Unitary Products Technical Services Service Tips Letter

Letter: **ST-003-2017**

Subject: LX Series residential package unit defrost curve selection

DEFROST CURVE JUMPER

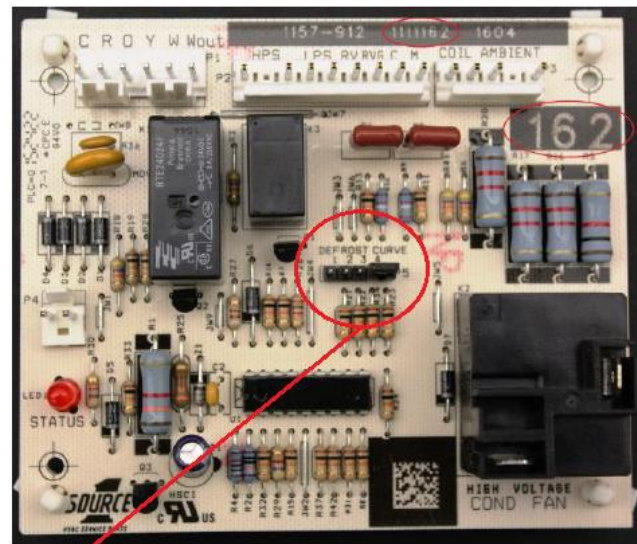
During random package unit testing a nuisance defrost issue was identified on a PHE4A3021A model residential package unit. Under certain indoor and outdoor ambient conditions, the pre-selected defrost pin position 3 may generate unnecessary defrost cycles. A factory deviation has been issued so that units currently being produced will be set on defrost curve 2 instead of 3.

If an installed unit experiences unnecessary defrost cycles, simply disconnect power, move defrost jumper from pin 3 to pin 2 and restore unit operation. If you have any questions please contact UPG Technical Services residential distributor support.
